CITY OF HAM LAKE PLANNING COMMISSION AGENDA MONDAY, NOVEMBER 14, 2022

Memorandum

Date: November 10, 2022
To: Planning Commissioners
From: David A. Krugler, City Engineer 
Subject: Bobby's Car Wash

BOBBY'S CAR WASH

LANDSCAPE PLAN
SITE LIGHTING PLAN
Sheet Number

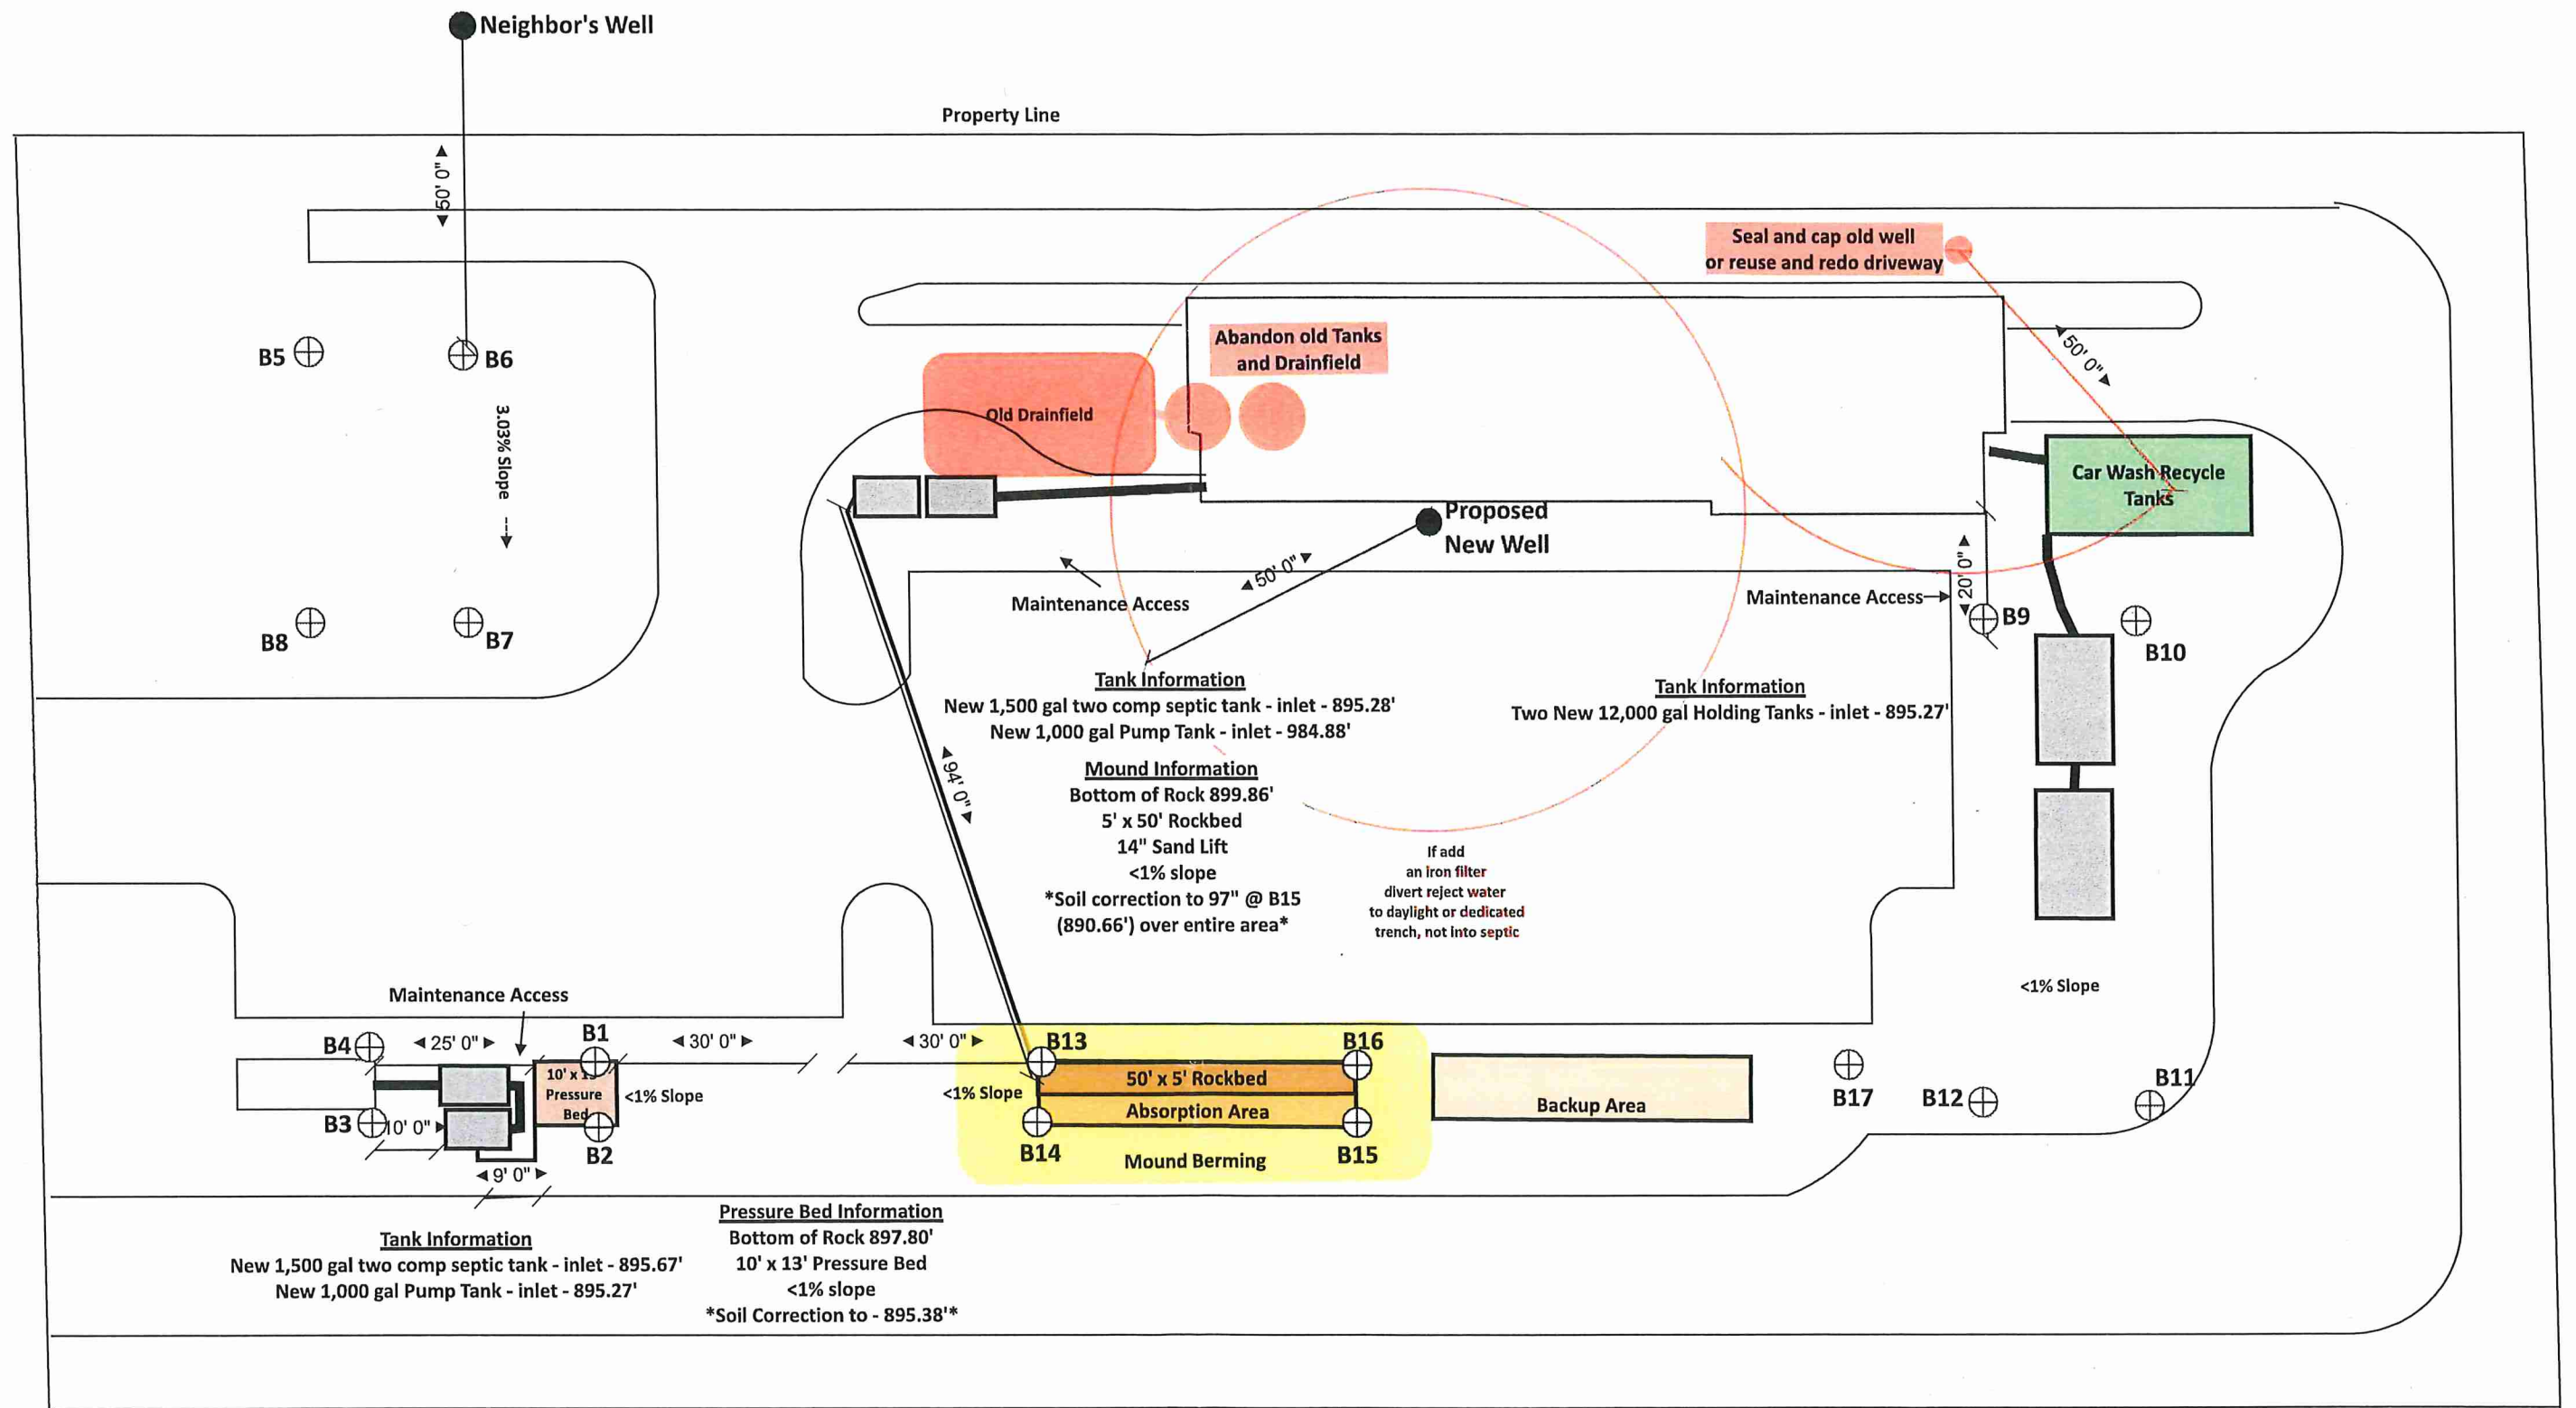
Landscaping in commercially zoned areas is to be per 11-1850 of City Code (attached). 11-1860 allows for case-by-case evaluation for landscape approval and "strict adherence to the remaining provisions of Article 11-1800 may be unnecessary where size, spatial relationships, topography or other physical features render a given landscaping plan aesthetically acceptable, and departures from the strict observance of the elements of Article 11-1800 shall not be considered variances requiring a showing of physical hardship. Conversely, an applicant shall be expected to meet the general spirit of this article in establishing an aesthetically pleasing landscaping plan". The plan shows two Flowering Crabapple trees at the west lot corners.
